# NATIONAL RADIO ASTRONOMY OBSERVATORY

ELECTRONICS DIVISION TECHNICAL NOTE NO. 105

TITLE: DIGITAL CONTINUUM RECEIVER HARDWARE MODIFICATIONS

DATE: January 6, 1982

STATUS WORD GENERATOR  
CLOCK INHIBIT  
ADDITION TO CARD 6 SLOT 11  
(REF PAGE 59)  
FIG 1

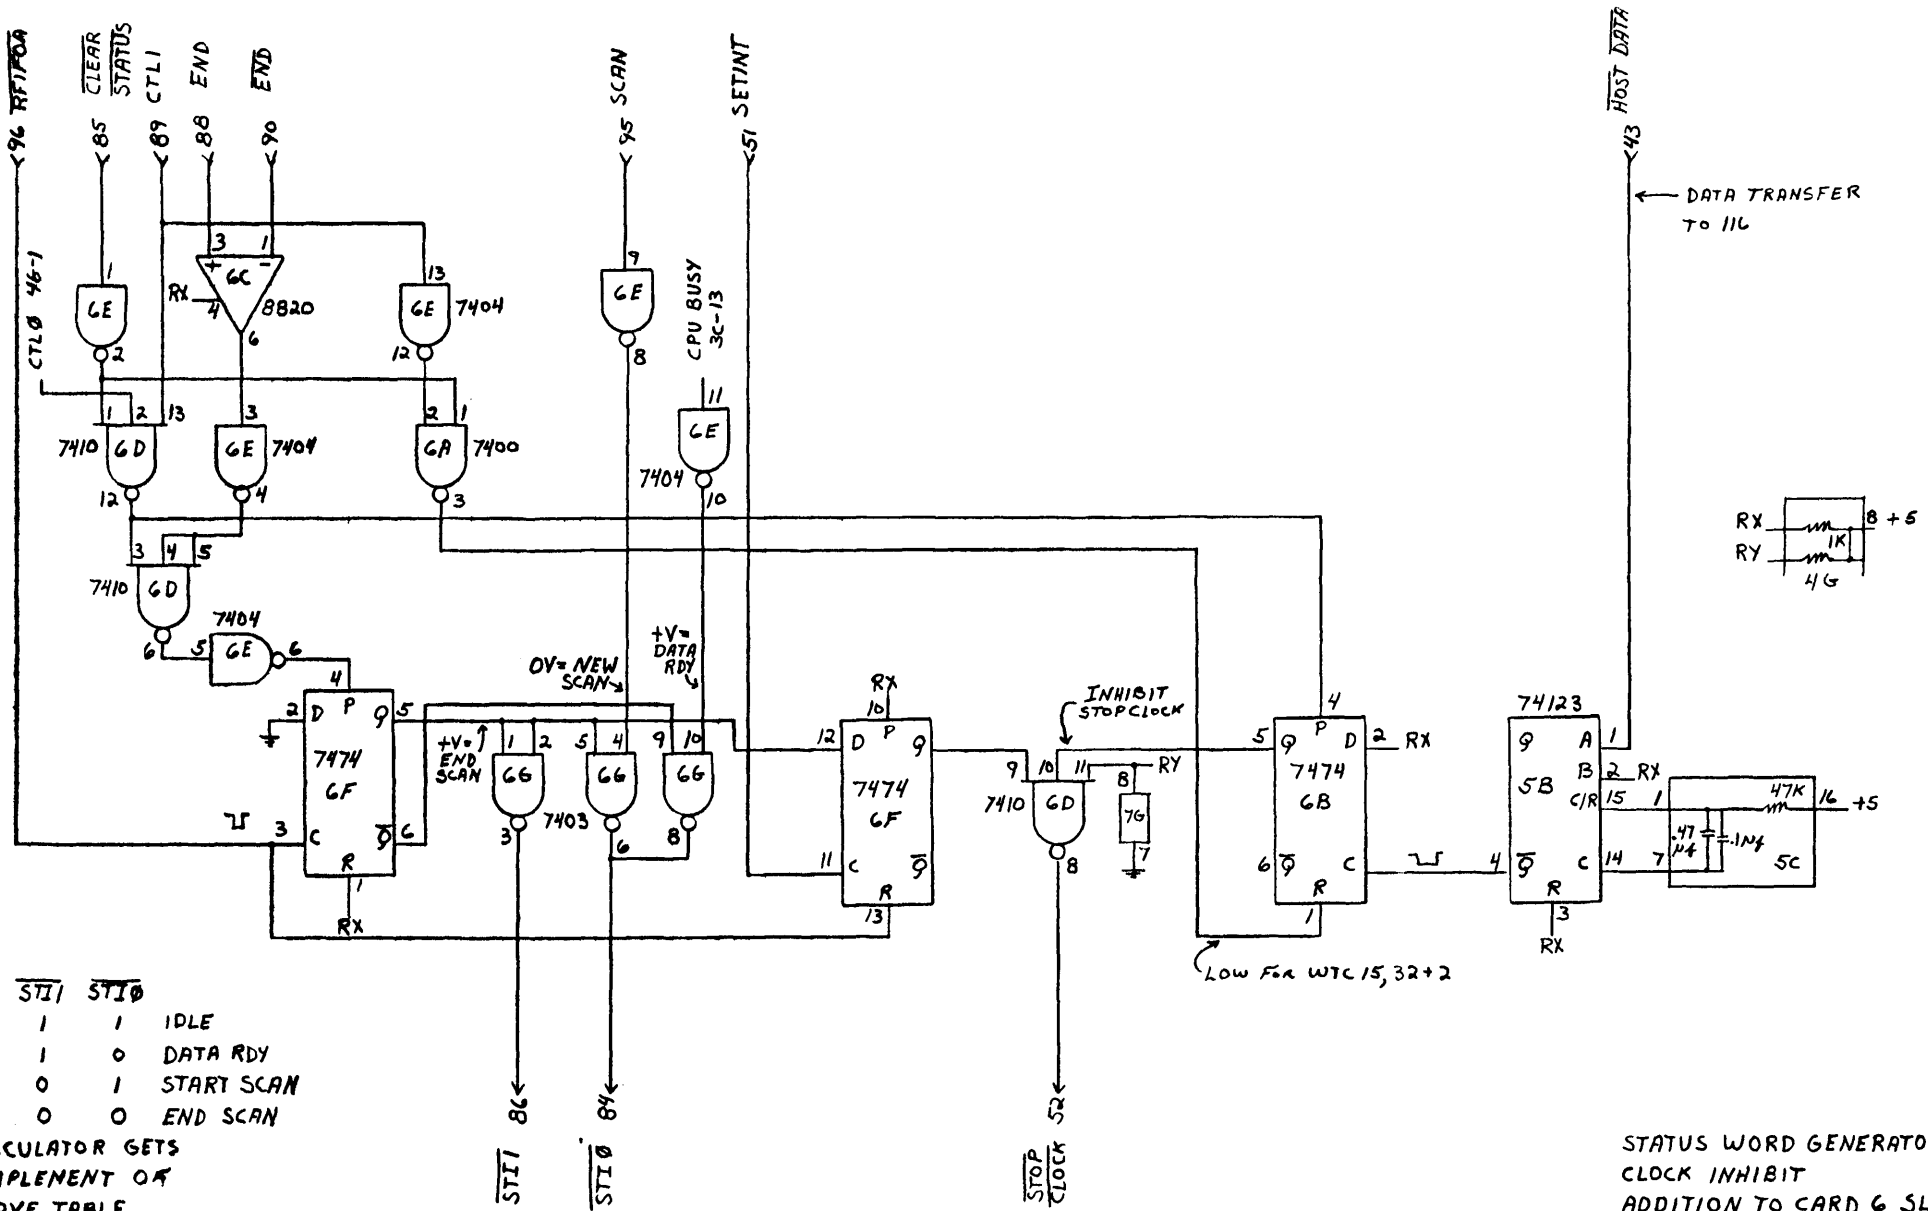
The program had to be changed so that it could determine in a reasonable amount of time when to start a new scan. This was accomplished through the addition of two status bits. (See Figure 1.) These two status bits enabled

the calculator to wait for a start scan condition, after the scan has stopped. The disadvantage of this approach is that a display of receiver parameters is not displayed between scans. In order that the calculator could guarantee a stop scan condition at start up, a new command was added. This command, WTC 15, 32. forces a stop scan. When the receiver is in a stop scan condition it spends all of its time waiting for a start scan. When the scan is started, all of the time base counters (EDIR 188, page 49) are reset (Figure 2) and the calculator is now waiting on data ready or another stop scan. Being able to wait on a start scan condition reduced the time from the host computer's request to a start scan to the cycle time of the calculator.

FIG. 3

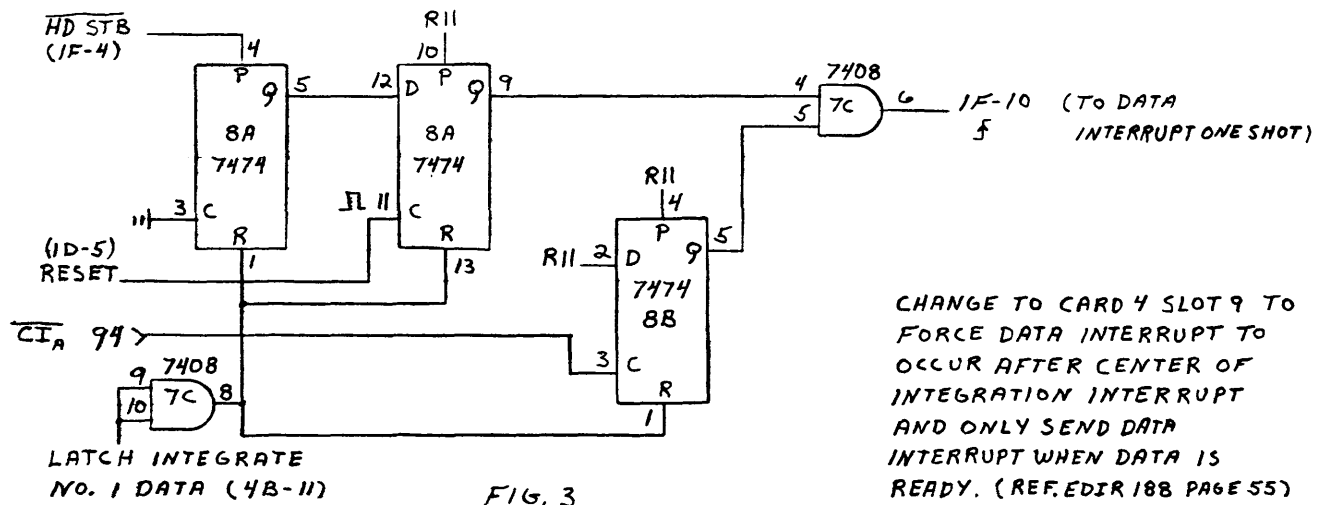
This flag caused a problem in that if a data interrupt should happen to occur while the flag was still set the host computer would interpret that interrupt as another center of integration interrupt. The logic in Figure 3 takes care of this problem by forcing the data interrupt to occur after the  $\overline{CI}$  flag is gone.

FIG 4

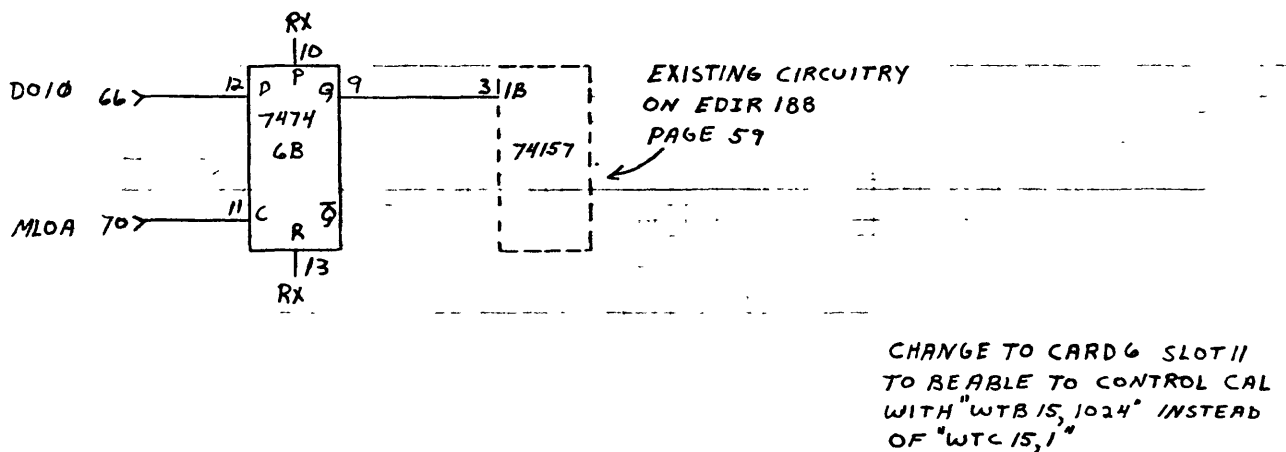
The addition of the WTC 15, 32 command caused another problem. This problem was corrected by the logic change in Figure 4. Before this change it was not possible to turn the cal off, due to the fact that when the control word was set to turn the cal off it also stopped the scan. The solution was to move the cal control to a write binary bit (1024) to control the cal.

CHANGE TO CARD 6 SLOT 11  
 TO BE ABLE TO CONTROL CAL  
 WITH "WTB 15, 1024" INSTEAD  
 OF "WTC 15, 1"

FIG 5

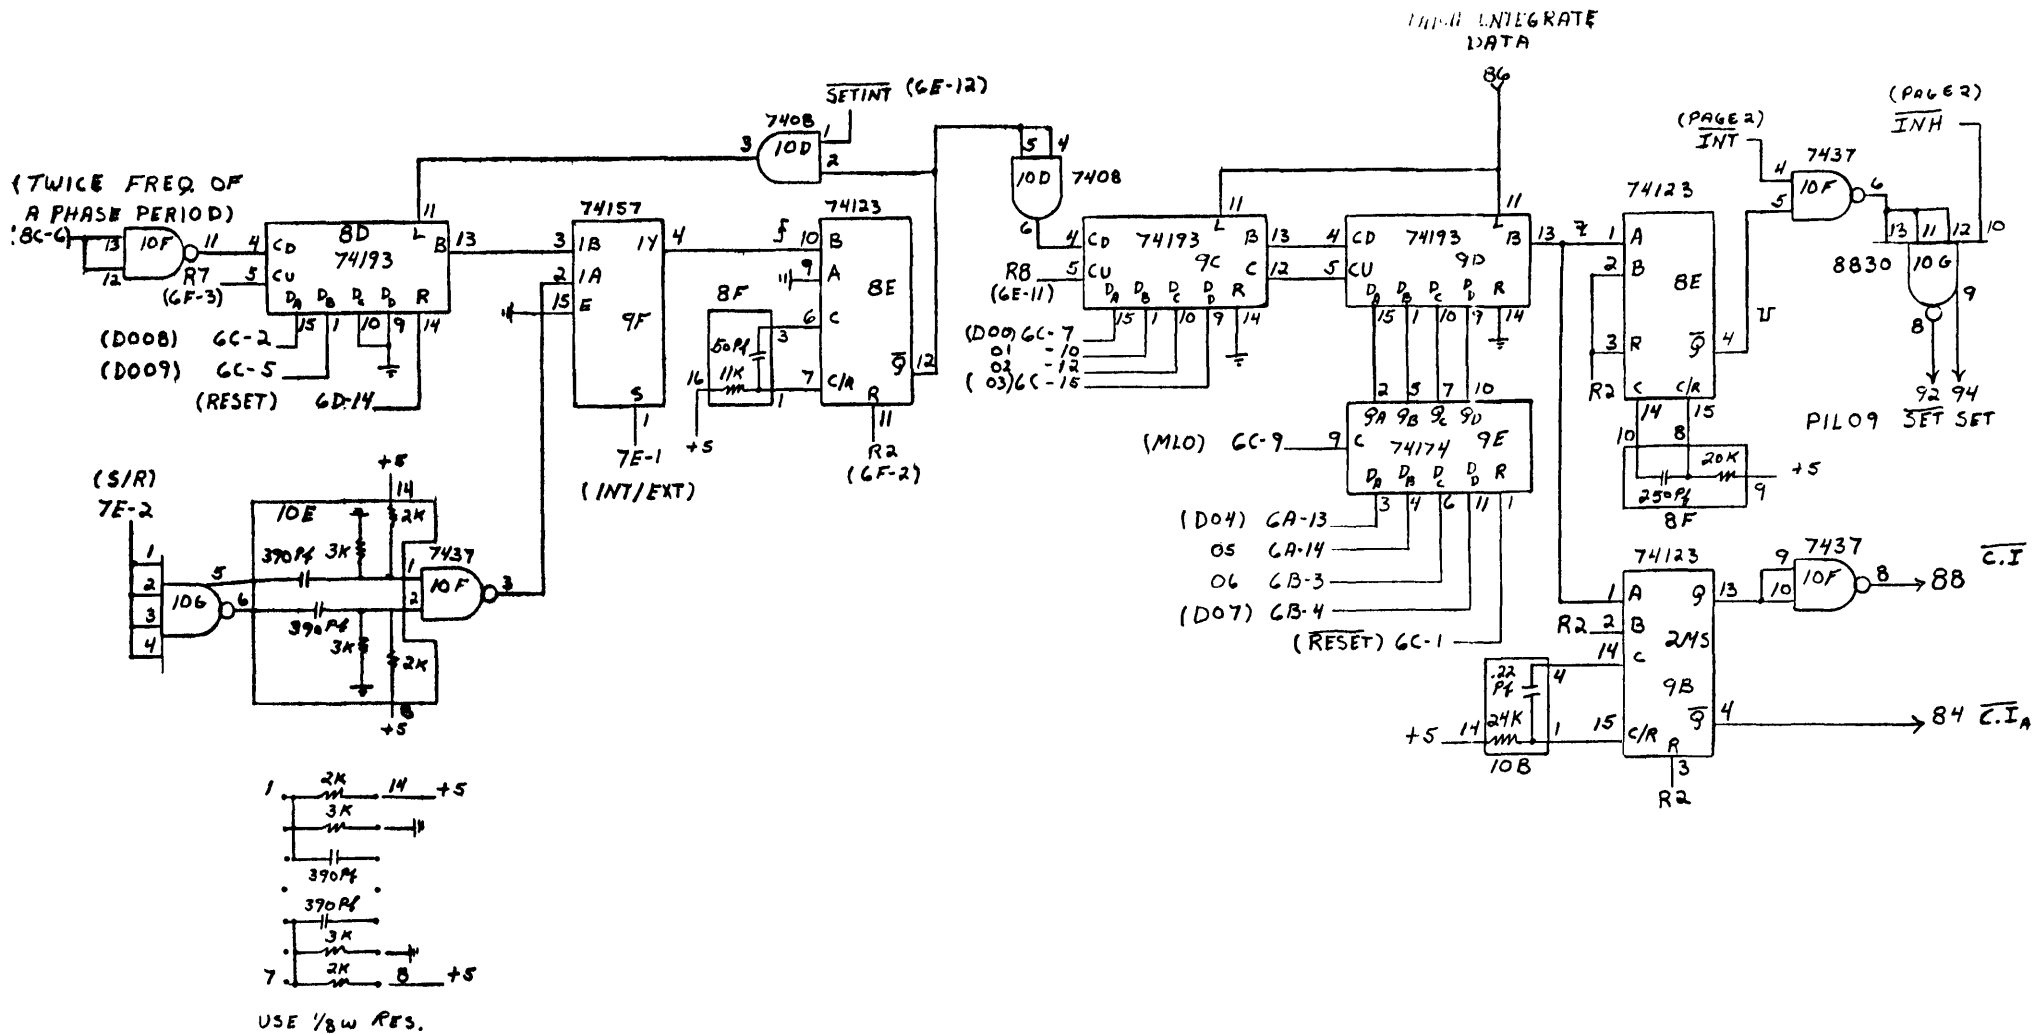
To generate a center of integration interrupt was rather an involved hardware addition. This was complicated by the fact that the host computer (300-ft DDP 116) only had one interrupt line that had to be shared as a data and center of integration interrupt. The approach used was to provide a flag  $\overline{CI}$  (reference Figure 5) to tell the host computer that it was a center of integration interrupt.

The logic of Figure 5 was implemented to generate a center of integration interrupt. The basic idea of the logic was to provide a duplicate phase counter (EDIR 188, page 49) and the samples/integration counter (page 55) and run these

counters at twice the frequency as in the normal counters. When these counters count down to zero it would be half way through the integration period and would generate an interrupt.

ADDITION TO CARD 1 (SLOT 3)  
TO GENERATE CENTER OF  
INTEGRATION INTERRUPT  
PAGE 1 OF 2  
(REF. PAGE 49)
